**Preservation Department – Item 1, LPC-25-05195**

**1040 Grand Concourse – Grand Concourse Historic District  
Borough of Bronx**

**165TH ST ELEVATION UPDATE**

# **BRONX MUSEUM OF THE ARTS**

# EXISTING STRUCTURE OBSERVED IN DEMOLITION

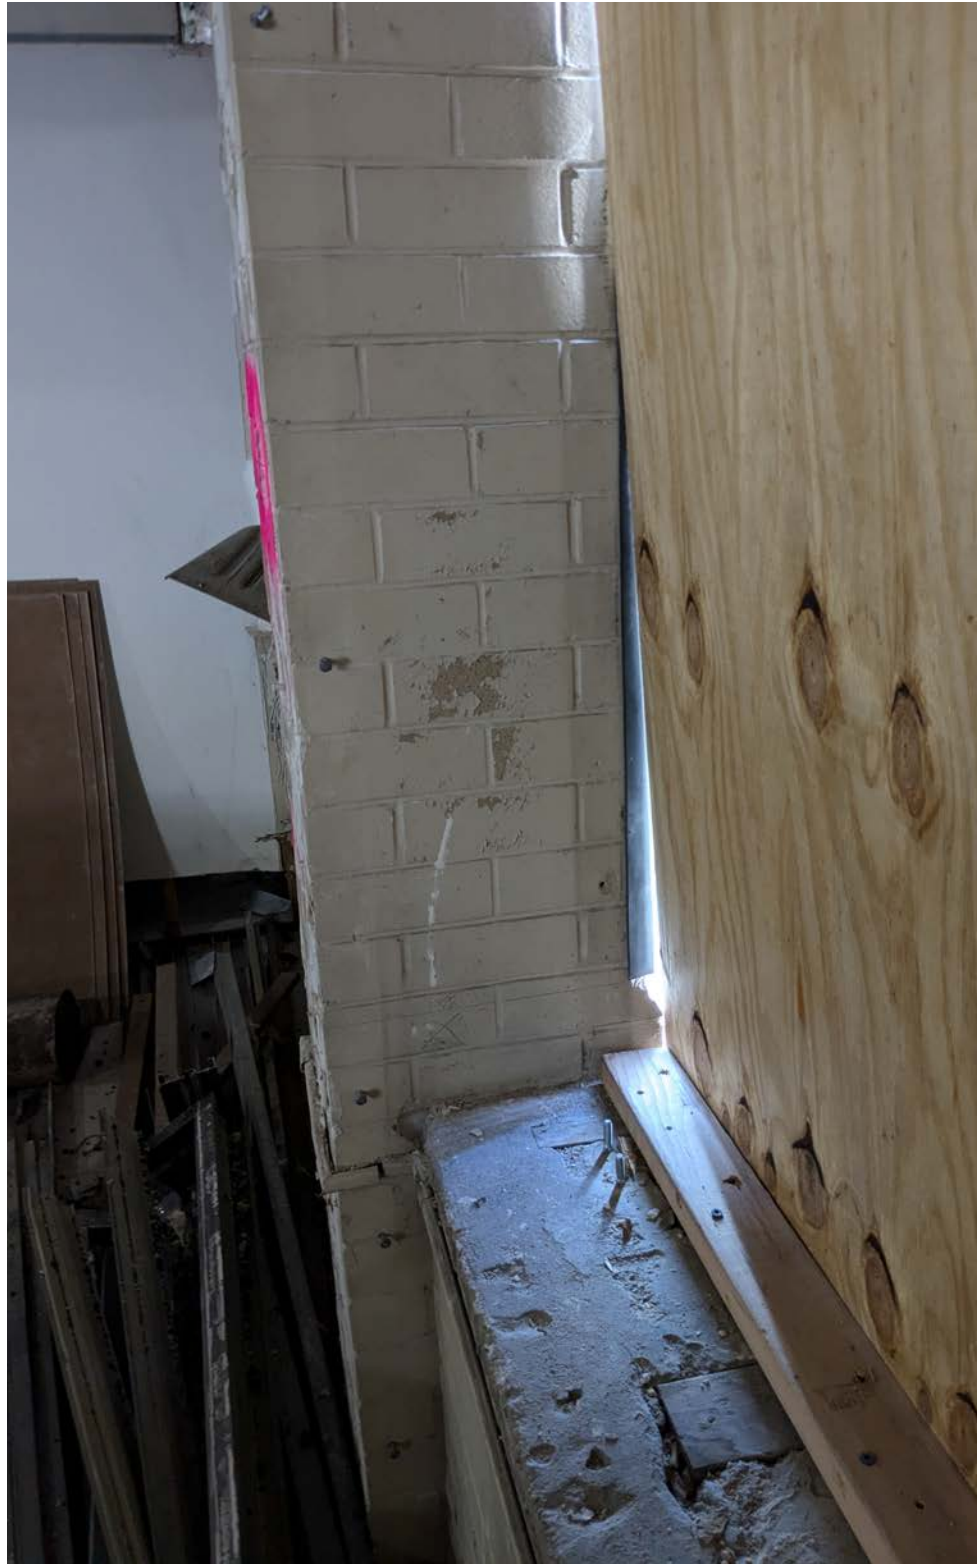
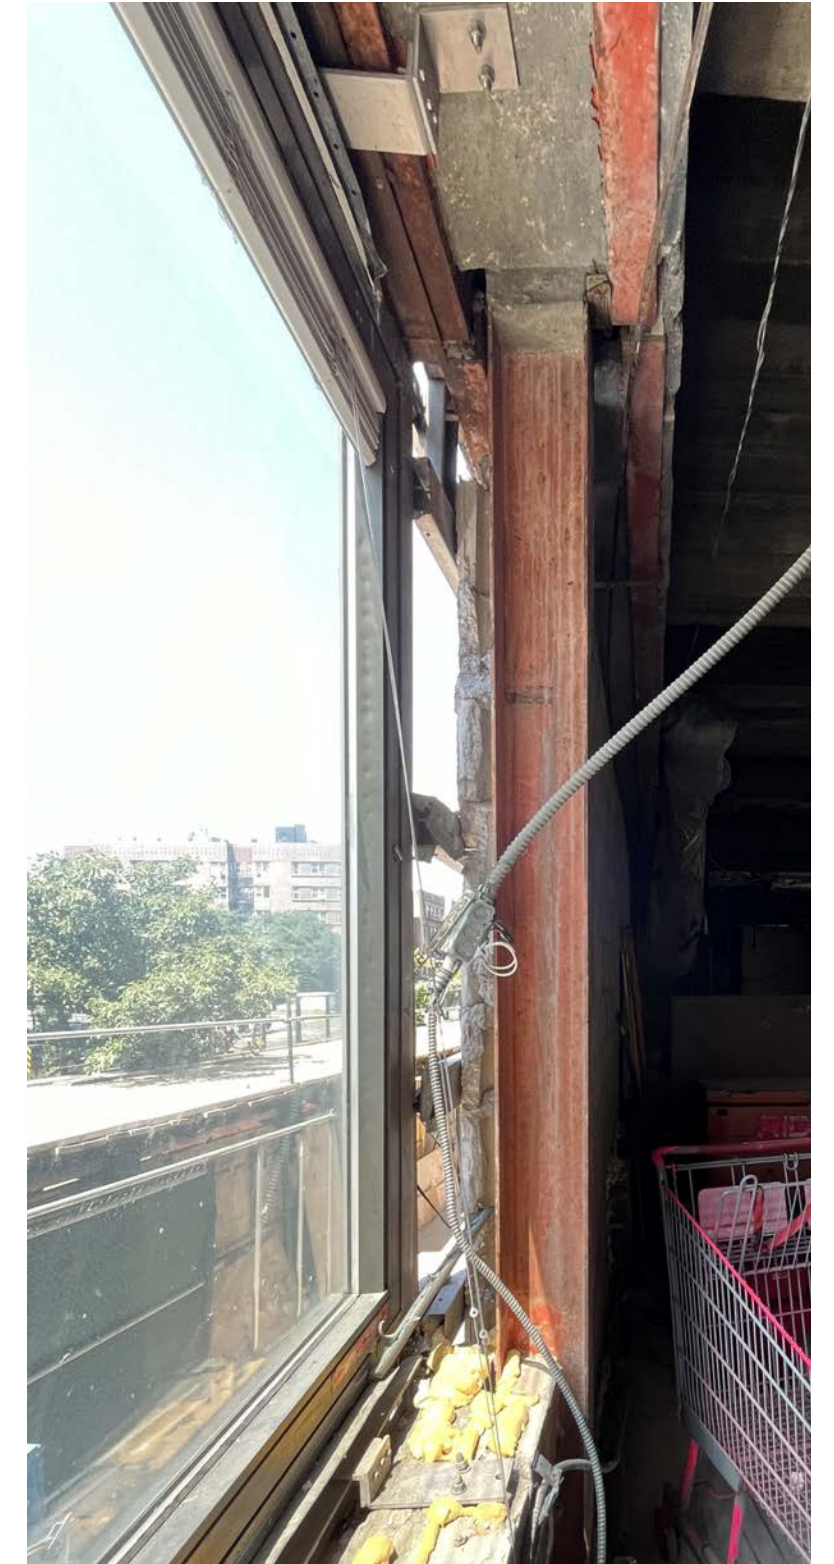
Existing columns are closer to the exterior surface than expected, and the continuous window will be broken by existing structure, or further project out to accommodate existing condition. The existing columns are wrapped in brick on the interior side as shown in the middle picture.

Existing window projected in front of the wall and column, and the layout does not relate to original structure,

# UPDATED WINDOW DESIGN - ELEVATION

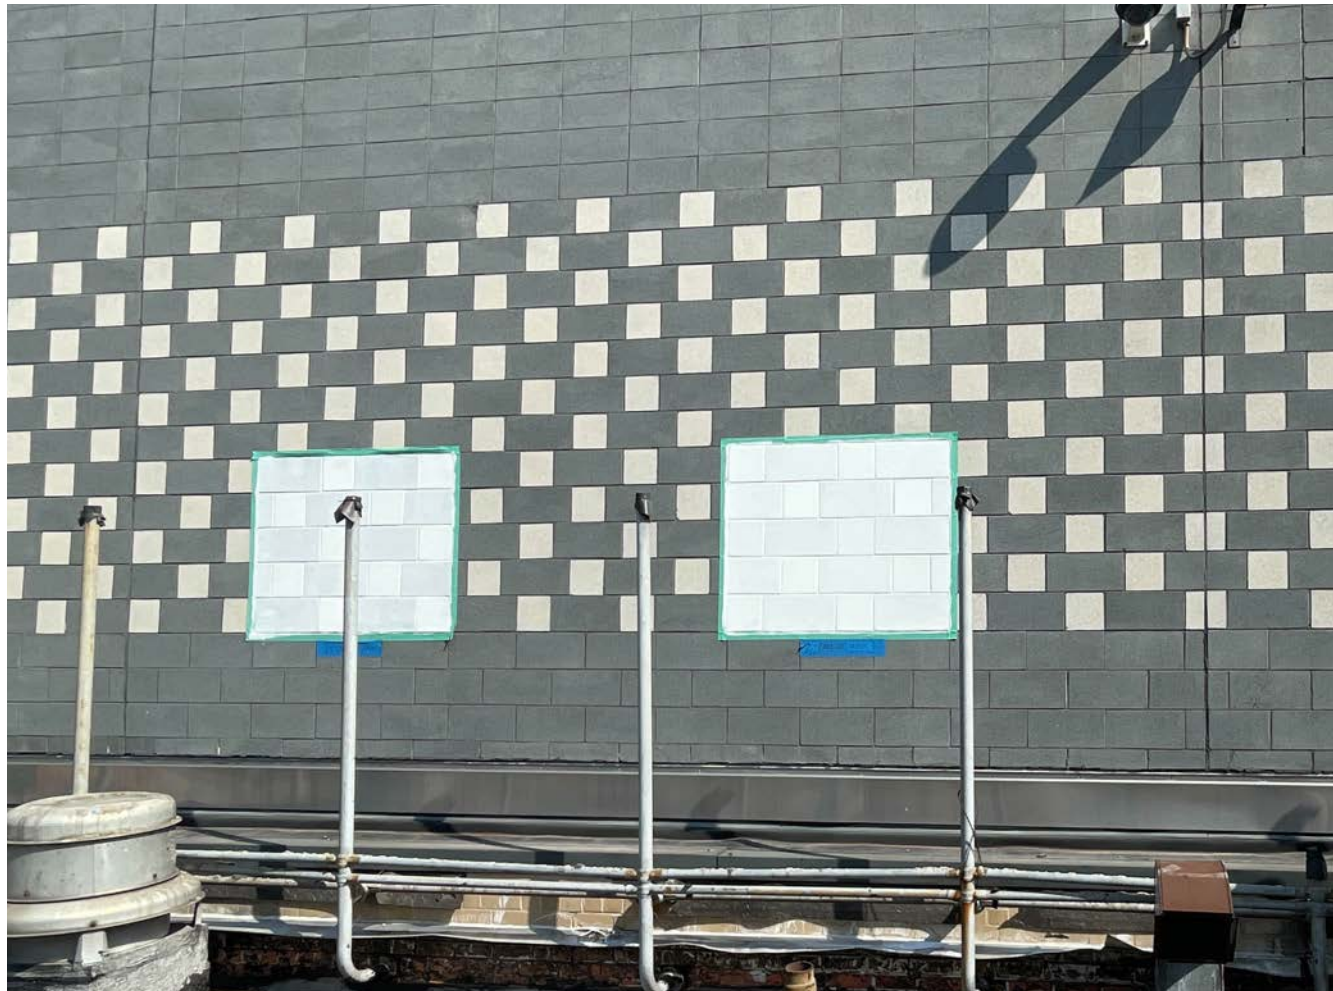
- Change from 5 window bays to 4 bays: This follows existing structure (similar to original synagogue design)
- Infill bricks (instead of metal panel) in between the windows: This creates a field of block-patchwork and a consistent backdrop for the new intervention, and avoid having the ribs that completely divide the elevation into striation. Using bricks also helps with not adding new material to the canvas that already has rich texture.
- Adding trim around the opening to create crisp edge condition and improve water-tightness.

## FIELD MOCK-UP - STAIN

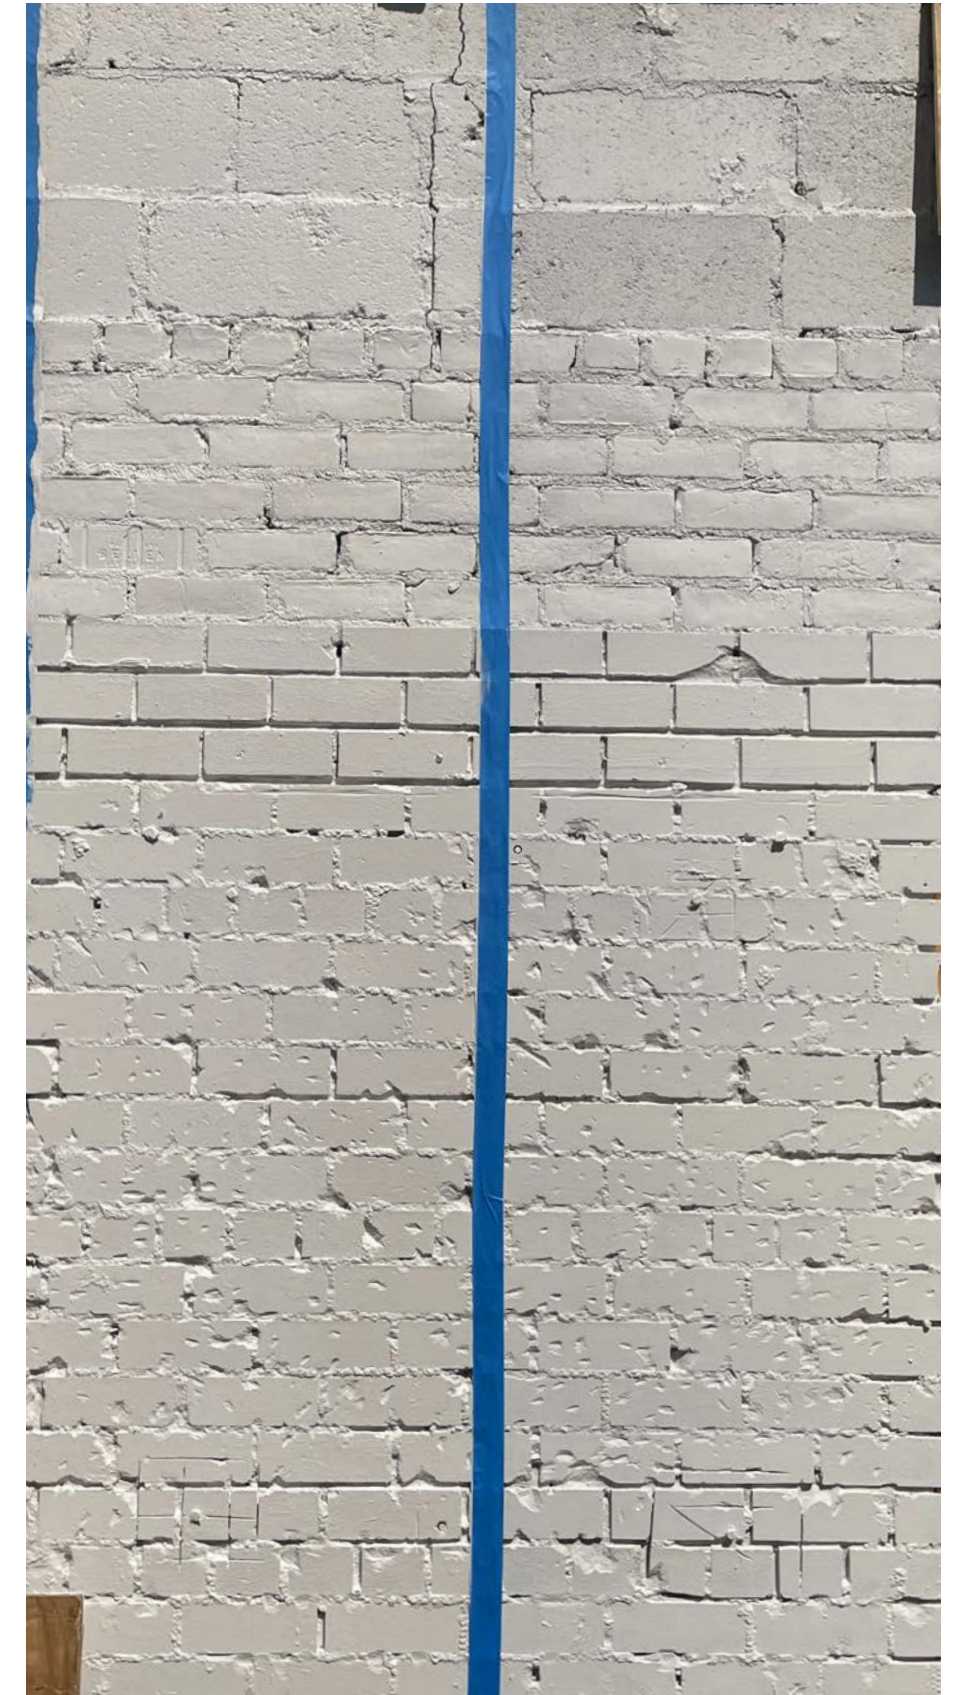
- Provide uniformed look, but maintain the existing texture/patterns and preserve the building's archeology.
- The color is not the final color in these photo, Mock up will be redone to match the color shown in renderings.

# EXISTING BRICK WALLS

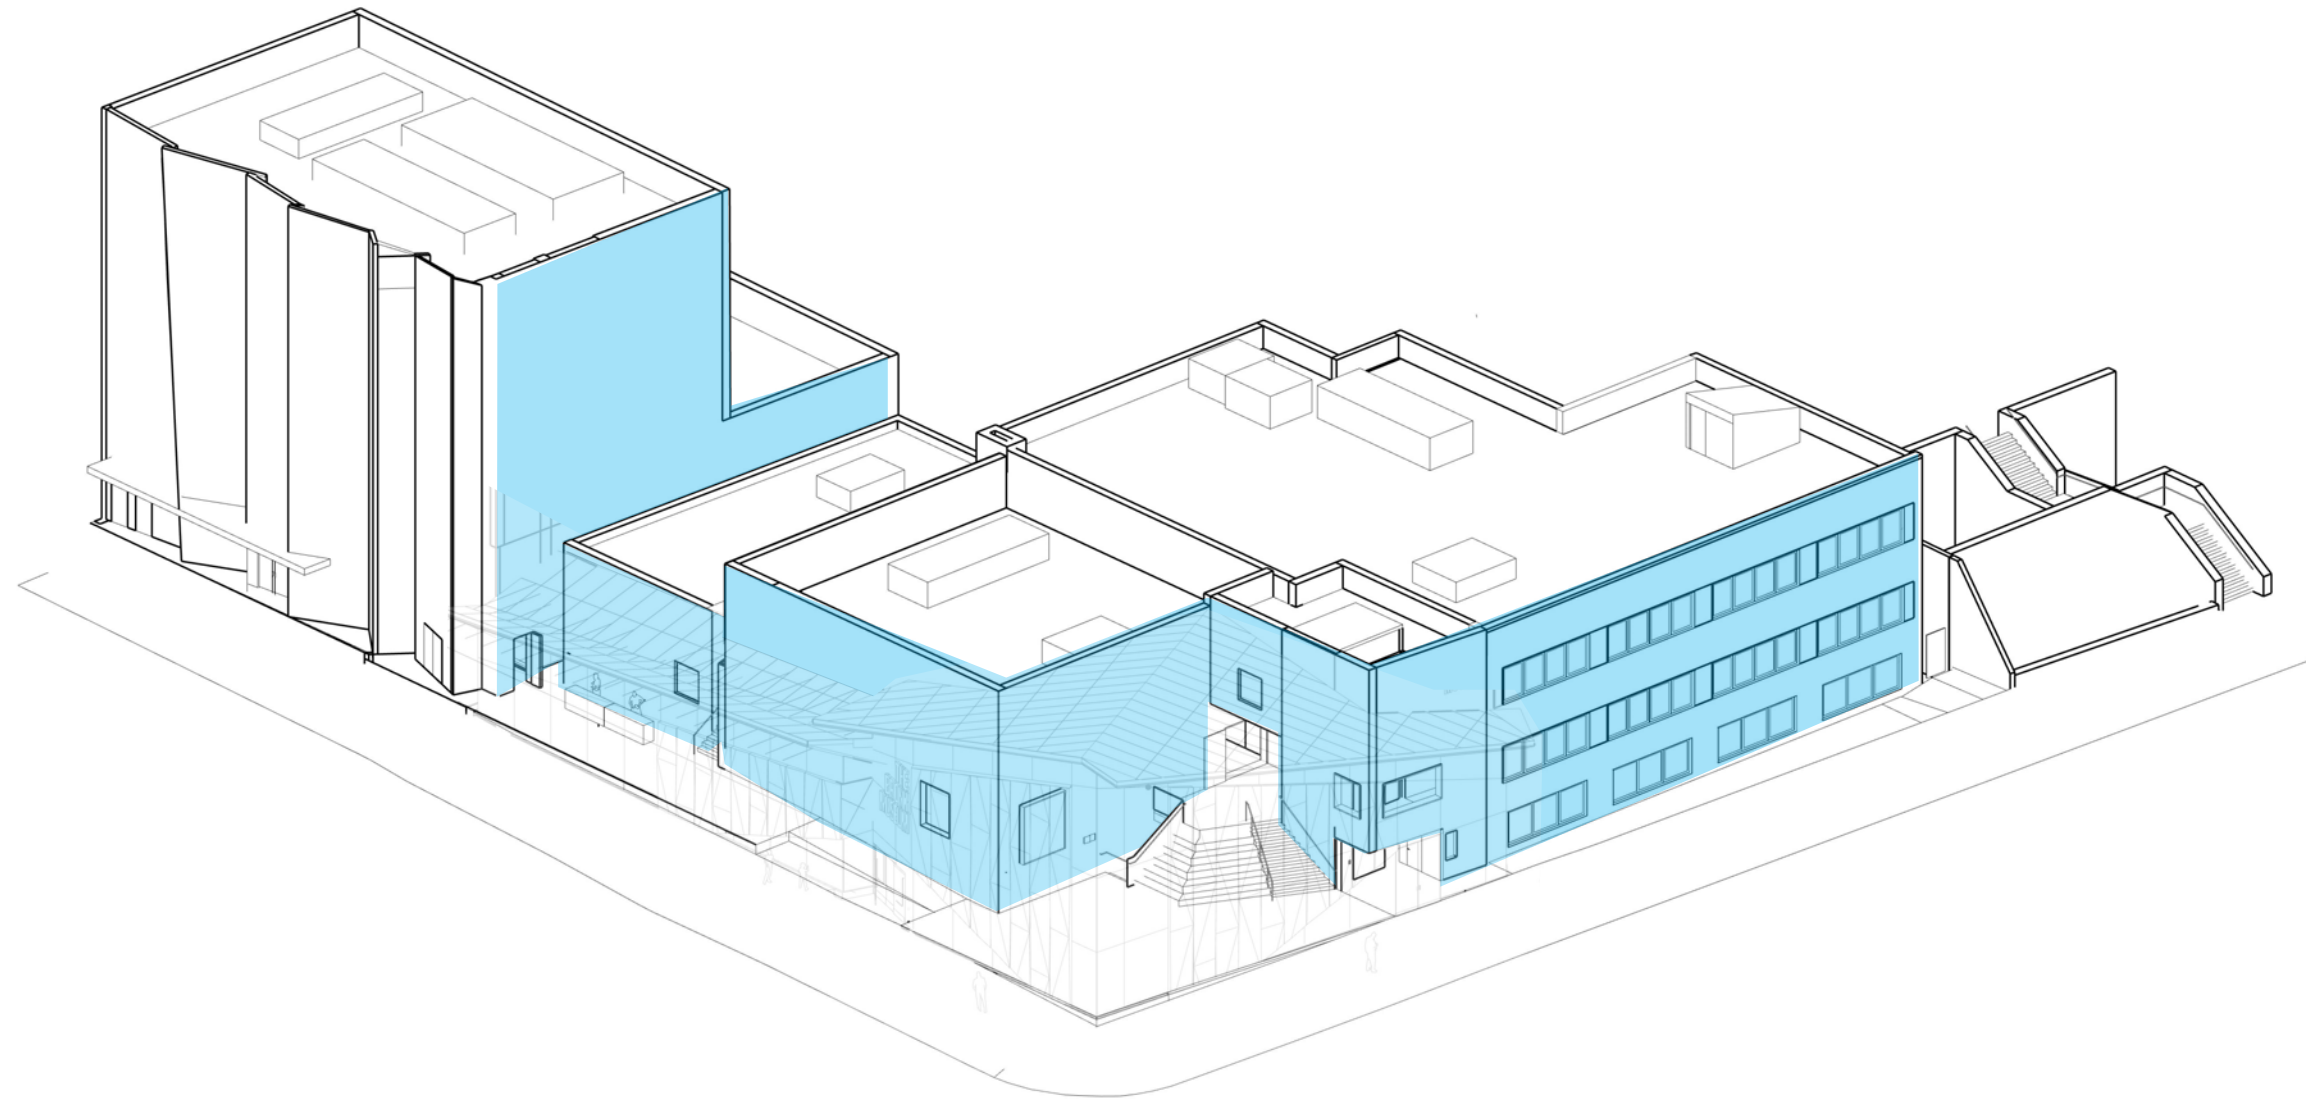
WE ARE INFILLING ALL TYPES OF OPENINGS ON THE EXISTING MASONRY WALL WITH BRICKS, AND STAINING ALL EXISTING BRICK WALLS THE SAME COLOR, WHICH WILL CONTINUE INTO THE INTERIOR SPACES AND CREATE A CONSISTENT AND COHERENT BACKDROP
